AGENDA

Greater Asheville Regional Airport Authority Regular Meeting
Friday, October 17, 2025, 8:30 a.m.
Council Chambers at Fletcher Town Hall
300 Old Cane Creek Road, Fletcher, NC 28732

D. Approval of Construction Contract Change Order No. 7 with Kokolakis Contracting for the Air Traffic Control Tower and Associated Facilities Project and Approve Owner Allowance Project Items (**document**)

E. Approval of Change Order No. 8 with Hensel Phelps for a Tower Crane and the Addition of a Construction South Access Road (**document**)

PROJECT: GREATER ASHEVILLE REGIONAL AIRPORT AUTHORITY ATCT & TRACON, 146 Westfeldt Rd, Mills River,	DATE: 02/14/2023
	DRAWN BY: SS
DESCRIPTION: STAIR-2 PLAN AT CAB FLOOR LEVEL (LEVEL-07)	CHKD. BY: PA
ARCHITECT: Pond and Company	P.O.NO.: ACA FL-245
CONTRACTOR: Kokolakis Contracting	SHT. NO.: E409

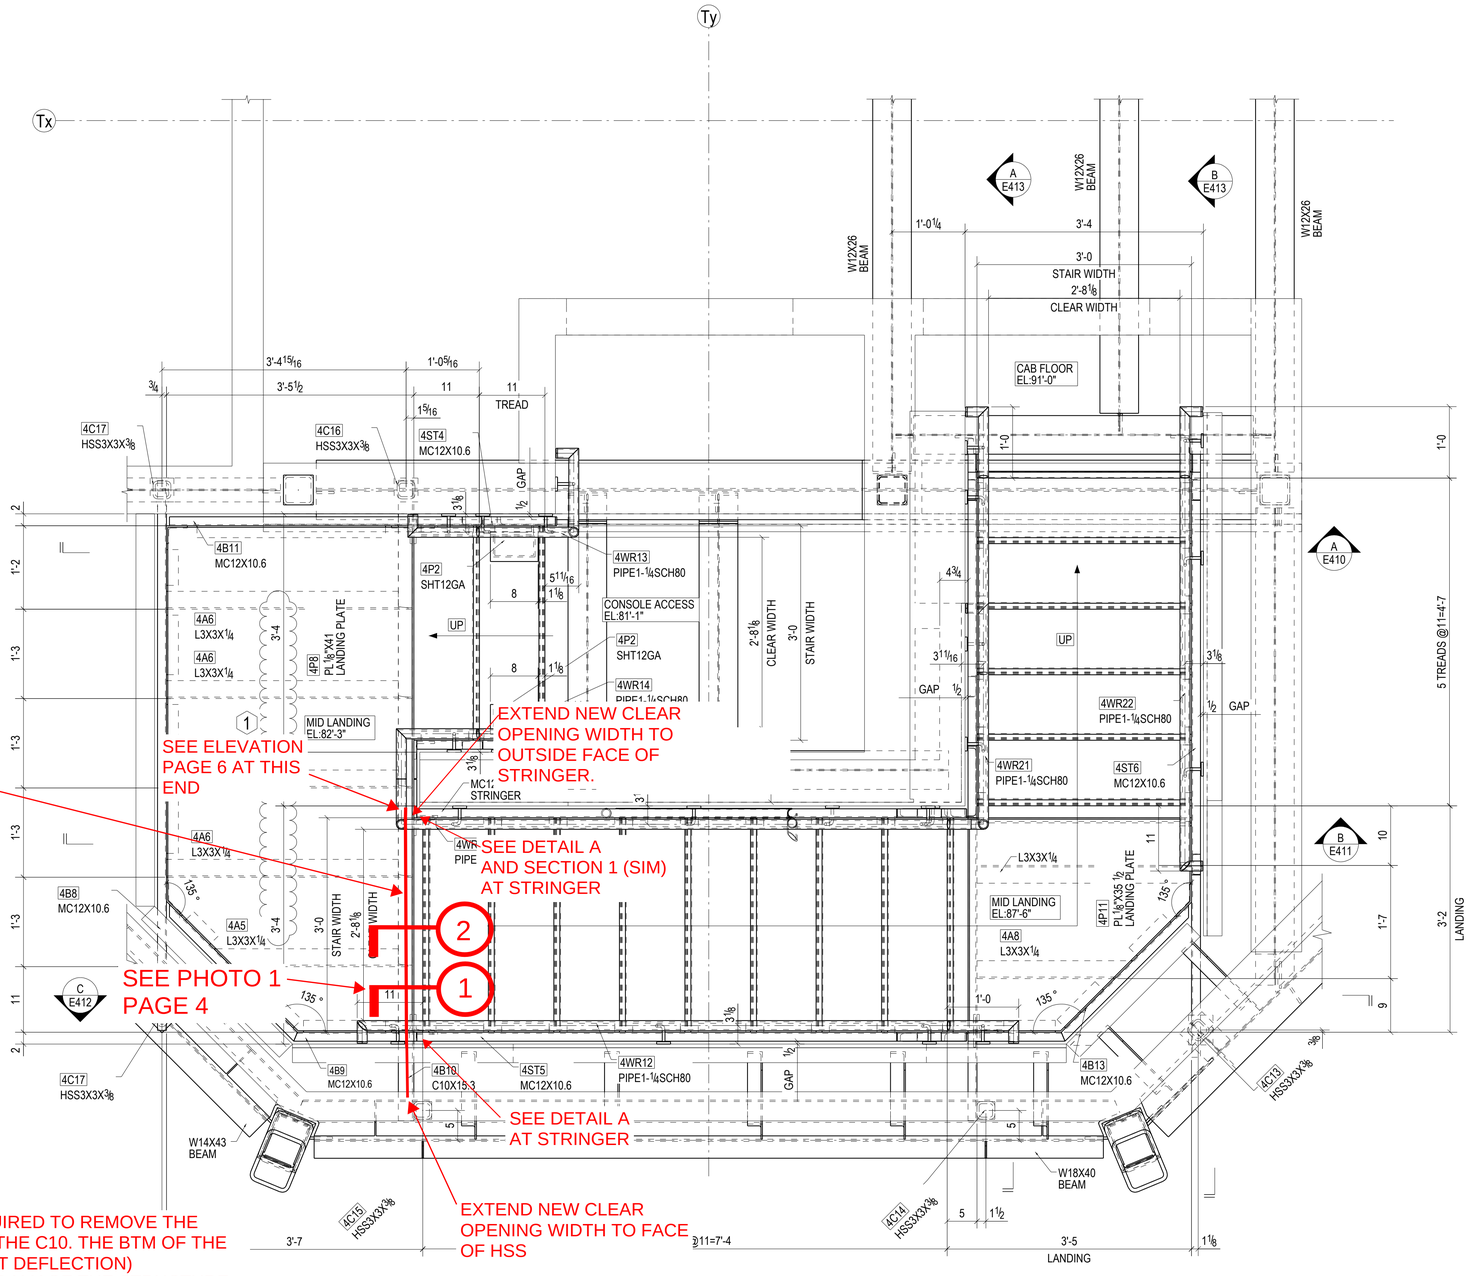
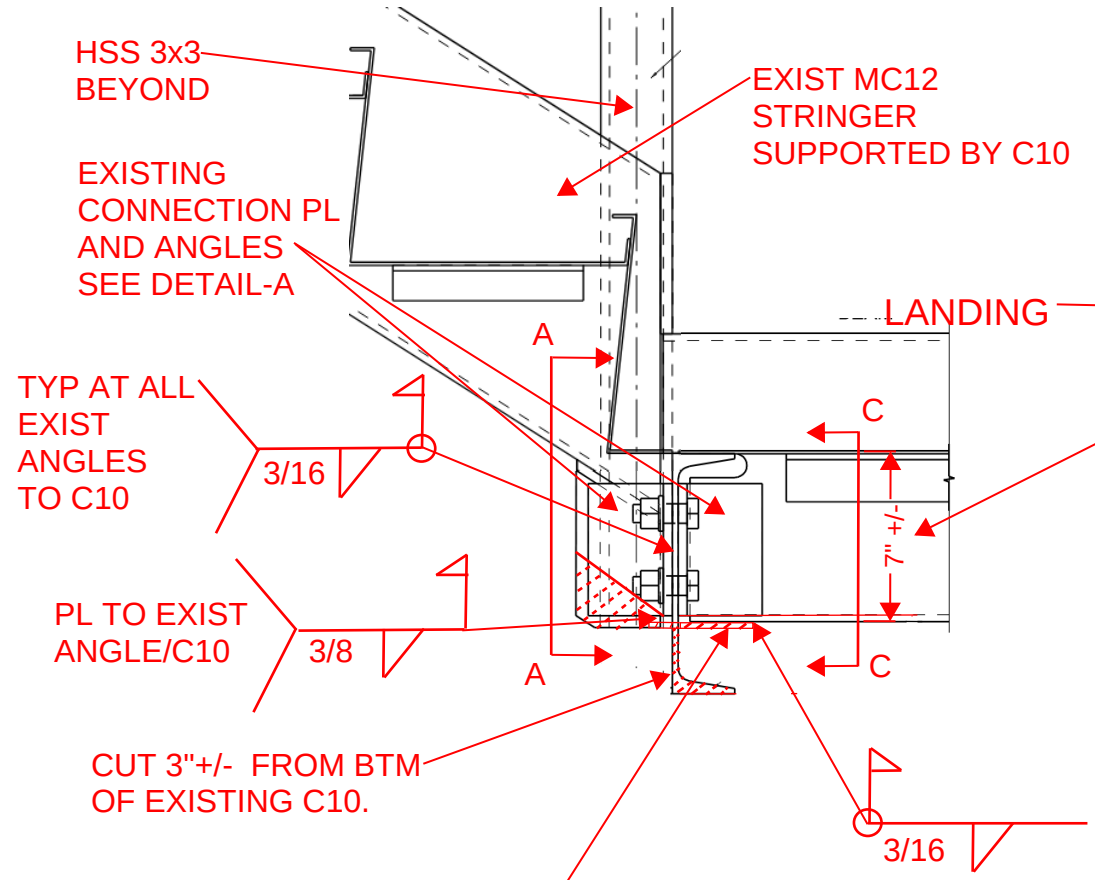
Question from Sean Thornton Kokolakis Contracting *on Thursday, Jul 3, 2025 at 12:57 PM EDT*

A1 STAIRWAY SECTION TO ENTRY PAVILION

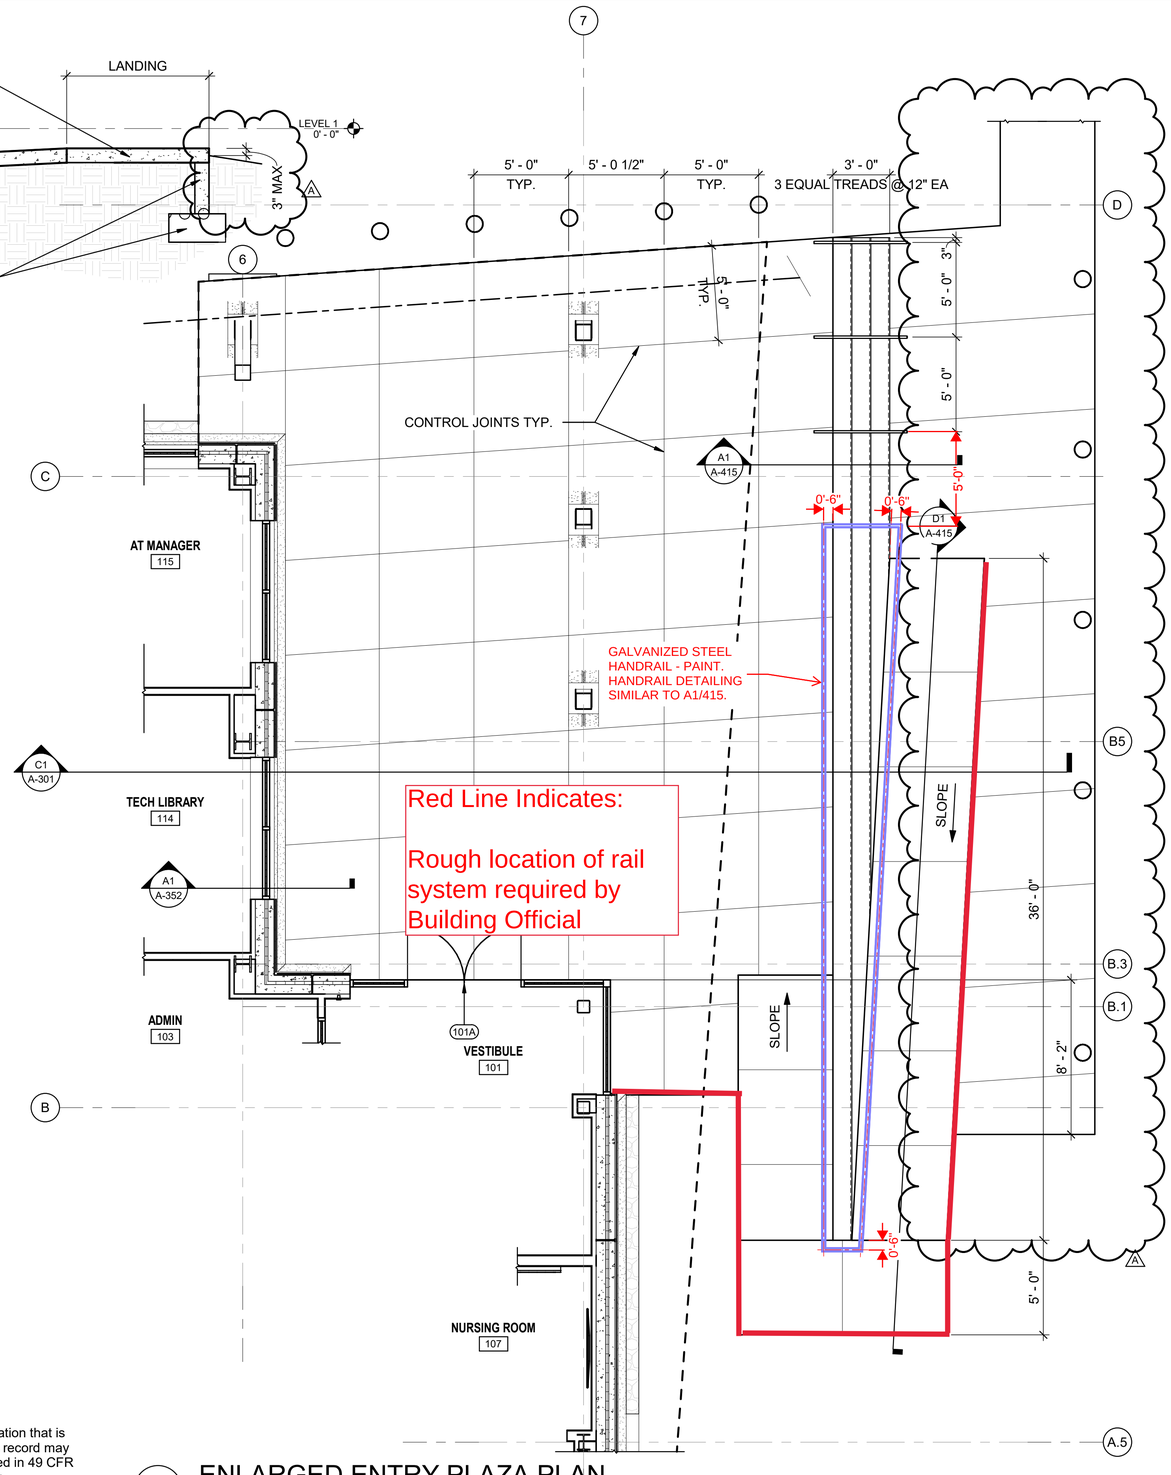
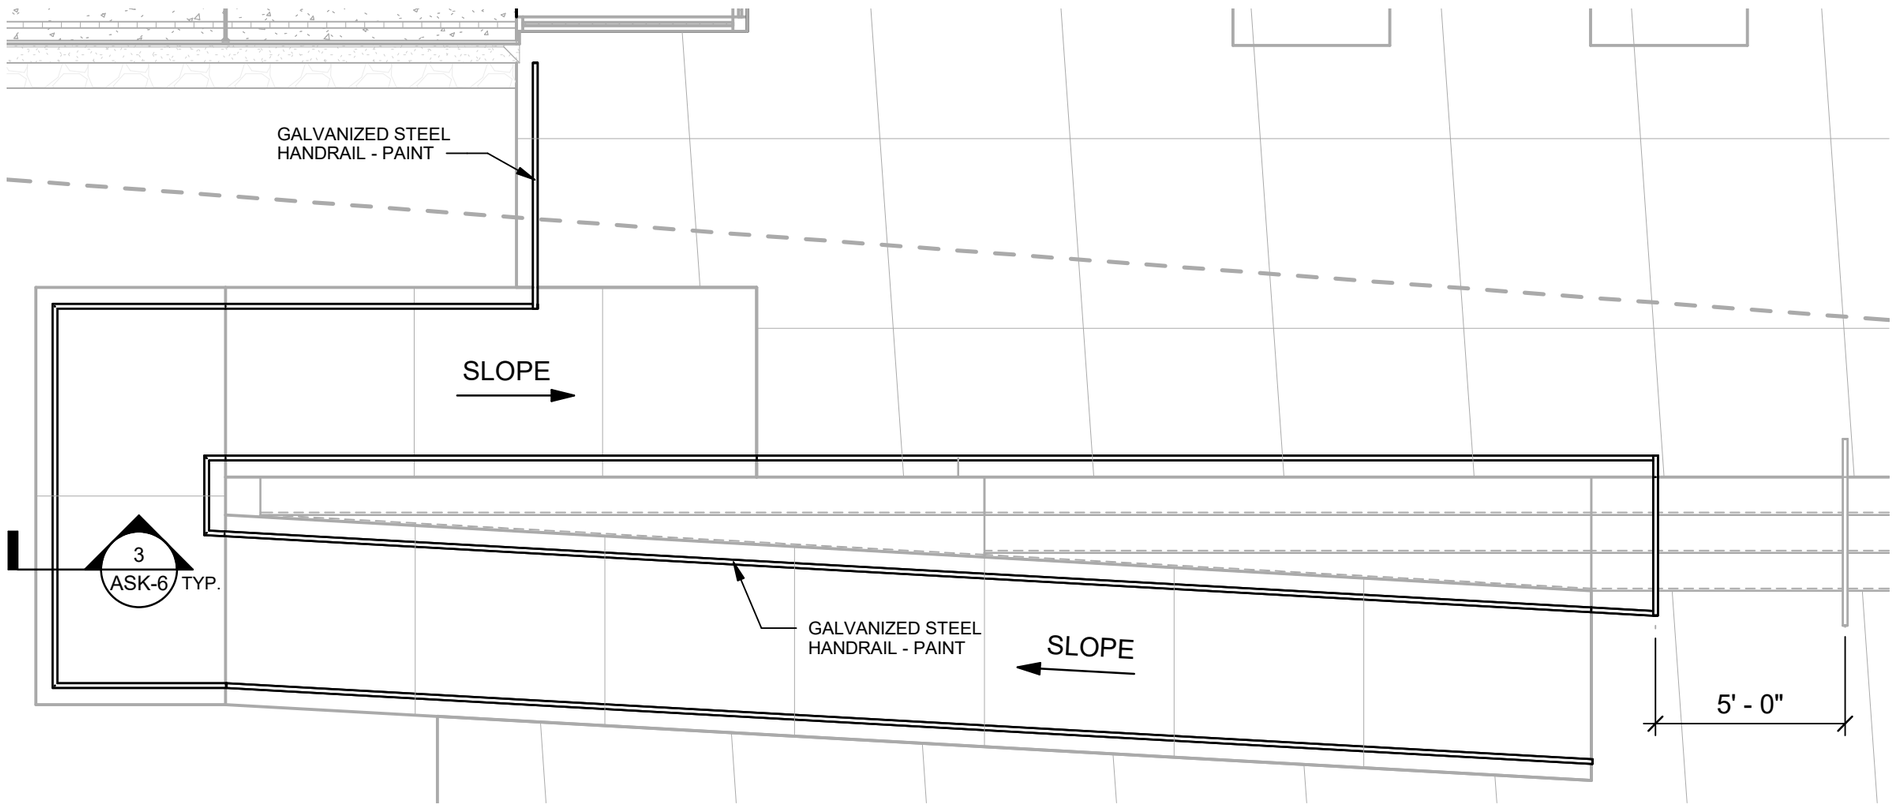
This determination directly contradicts the Architect's 8/18/25 response to RFI #256, which asserted that the entrance plaza does not constitute a ramp and therefore does not require handrails under ANSI A117.1 or guardrails under NCBC. Further, the Architect's 8/18/25 response to RFI #256 did not provide the information specifically requested by Kokolakis. Our RFI sought:

As a follow-up to RFI 256 regarding the entry plaza canopy stairs that merge with the ramp (reference Sheet A-415), we are requesting additional clarification to ensure proper coordination and installation of the handrail system. Specifically, please provide a plan view showing the full extent and routing of the handrail as it wraps around the outside of the stair and leads up to the building. The building inspector is requiring an outer rail to prevent anyone from rolling off as there is a drop-off due to the grading beyond the ramp. In addition, we request an elevation view illustrating the intended appearance and configuration of the handrails, as well as a detailed installation drawing showing mounting method, spacing, and any finish requirements. This information is necessary to ensure the handrail is fabricated and installed in full compliance with ADA and applicable building code standards.

1. This RFI makes reference to a "ramp". The entrance plaza that is being referenced does not contain a ramp. A ramp is defined as having a running slope greater than 1:20 and not steeper than 1:12 (2009 ANSI A117.1 - 405.2). The entrance plaza that is being referenced does however contain a walking surface. A walking surface does not exceeding a slope of 1:20, this is shown in the construction documents as well as depicted within RFI 256. A walking surface is a component of an accessible route (2009 ANSI A117.1 - 402.2).

Added updated sketch. DGM 09/17/25
